COUNCIL ASSESSMENT REPORT

Panel Reference	PPSNH - 117
DA Number	LDA2020/0229
LGA	City of Ryde
Proposed Development	The proposal comprises an Amending Development Application to modify the Concept Development Application approved under LDA2017/0547 with regard to land uses, building envelopes, site access, layout and staging. The application seeks to modify the approved Concept Development Application to: - Amend the approved land uses to include a data centre in addition to the approved retail and commercial uses. - Merge approved Building B, C and D to create one enlarged Building B which will accommodate a data centre. - Reconfigure and rename approved commercial office building 'Building E' to become 'Building C'. - Introduce new commercial office building 'Building D' - Amend the design of internal private roads, with no changes to Road 22. - Reduce the central publicly accessible open space fronting Khartoum Road, known as Bochetto Park from approximately 5,332sqm to 2,339sqm. - Reduction from 987 spaces to 765 car parking spaces. No changes are proposed to Building A or the Stage 01 approval under LDA2017/0547 for its construction.

Street Address	11-17 Khartoum Road and 33-

Figure 12. Approved Concept Approval (LDA2017/0547) (Source: 3XN)

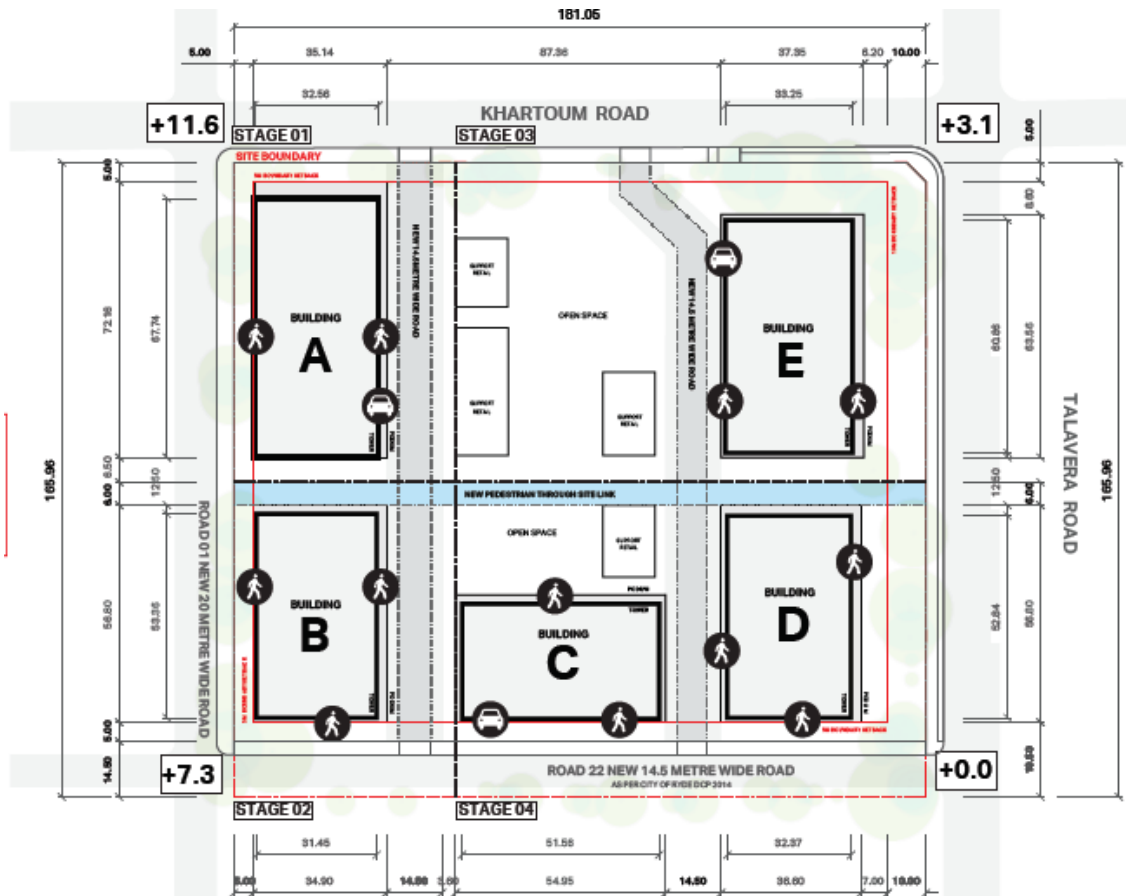
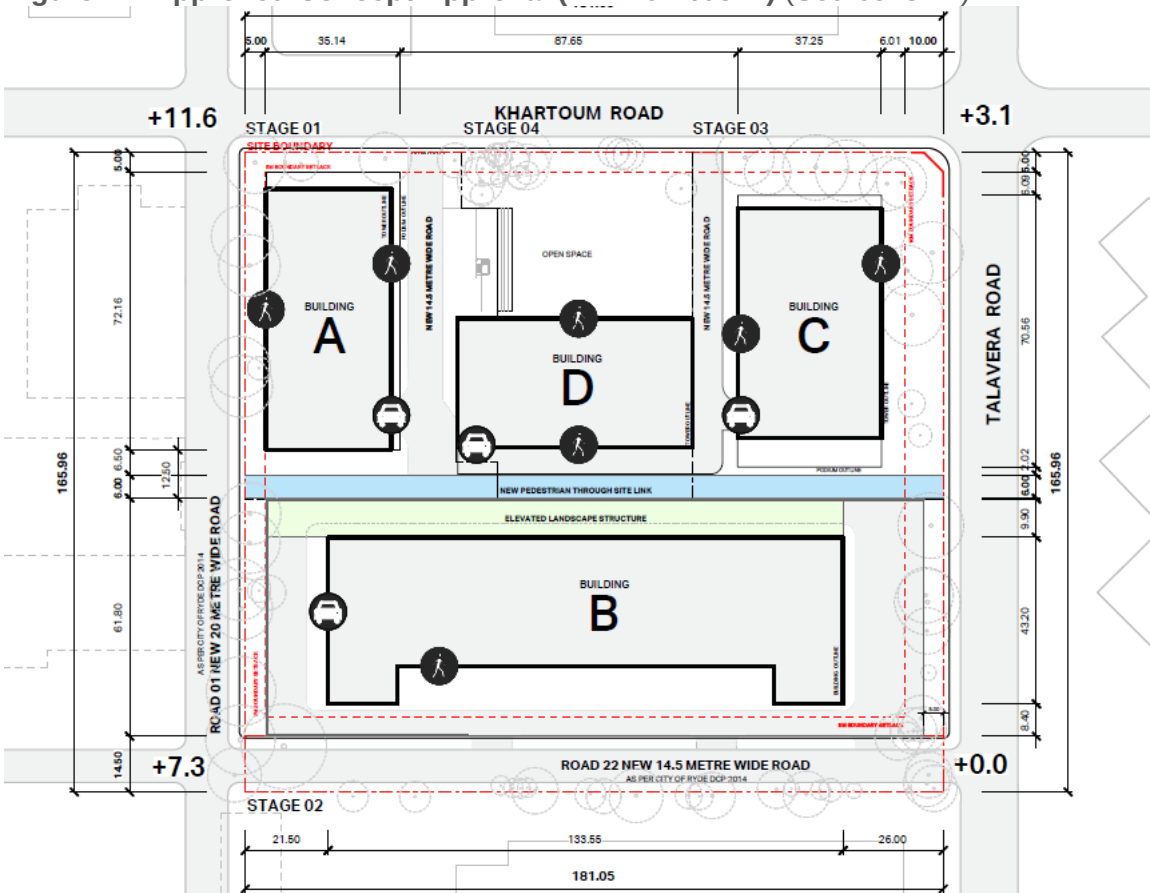
*I have provided a comparison of the approved and proposed amended master plans below for your reference, followed by my detailed comments (refer **Figures 12 and 13** earlier in this report).*

Figure 16. Section plan A (Dwg No. DA-020, Rev E, dated 01/10/2020)
(Source: 3XN Architects)

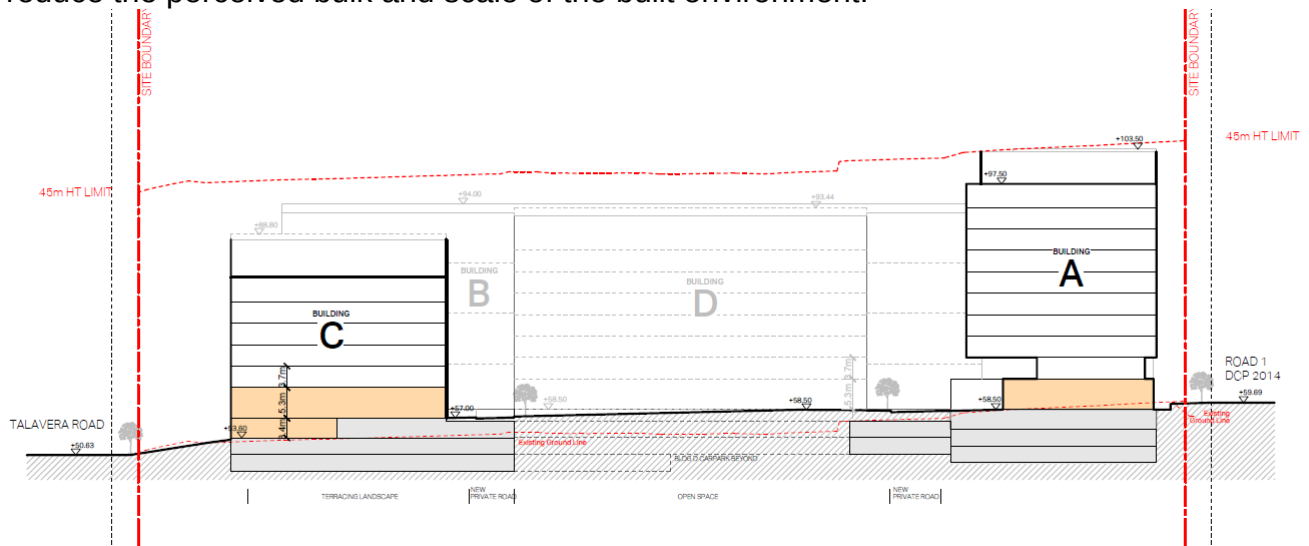
The proposal lacks the consideration of site levels and its interface with adjoining roads. As shown in drawing DA-020, there is substantial fill over the proposed open space, resulting in a steeper gradient and an unfavourable condition for recreational activities. The open space should allow for a generously sized levelled area to flexibly cater for a wide range of activities.

Figure 25. Building B Ground Plane showing location of security fencing
(Source: Stockland. Dwg Number Data_SK7A, dated 29.09.20)

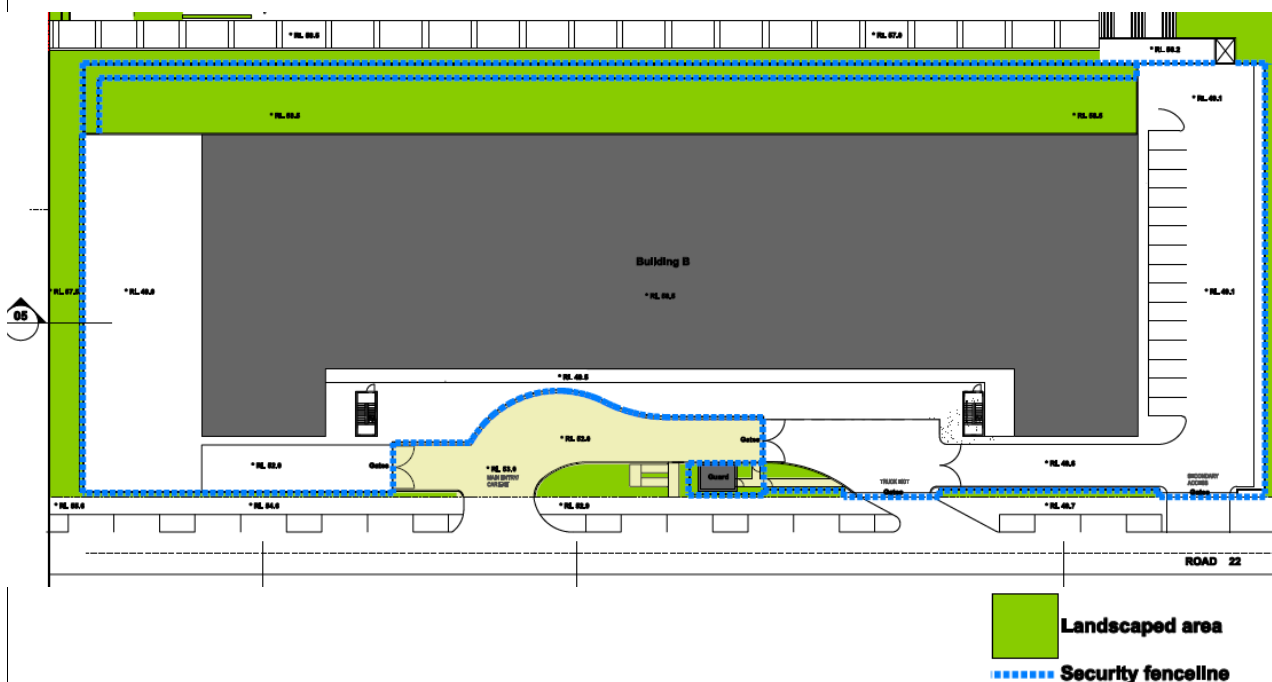
- Section 8.8 'Fencing' states "*Fencing is not permitted on the perimeter boundary of sites. Security should be provided within buildings*". The proposal includes 2.4m fencing, with double fencing proposed in some areas around the periphery of the Building B site as shown at **Figure 25**.

Figure 27. Section plan of proposed Buildings B data centre
(Source: Stockland Presentation to Council 17.8.20)

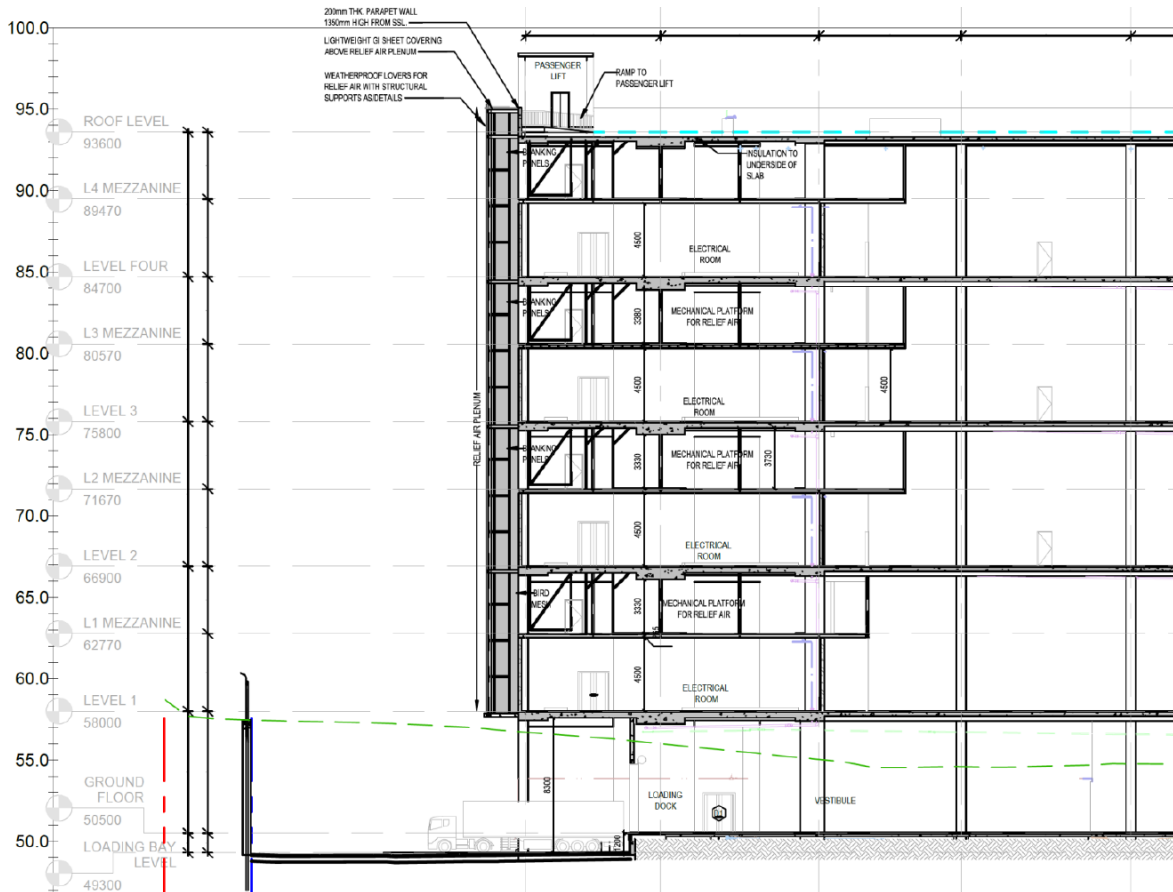
The building has a slab to slab height of 8.9m (see **Figure 27**) as a result of the energy efficiency standards proposed for the data centre cooling system. As a result, the 5-storey 45m high building appears as a 9-10 storey building, contributing to the overall bulk and scale of the development.

The cross section plan provided to Council (**Figure 27**) shows that each level has a series of mezzanine levels to support an electrical room on the base level, with mechanical platform above for relief air. While the precise design of the development will be subject to the SSD assessment, the applicant has provided elevation plans to show the proposed façade treatment that is to be included under the SSD Application (see **Figures 28 and 29**). With these details, Council is satisfied that the

overall bulk and scale of the development will be adequately designed to prevent large blank expanses of the building and provide visual interest.
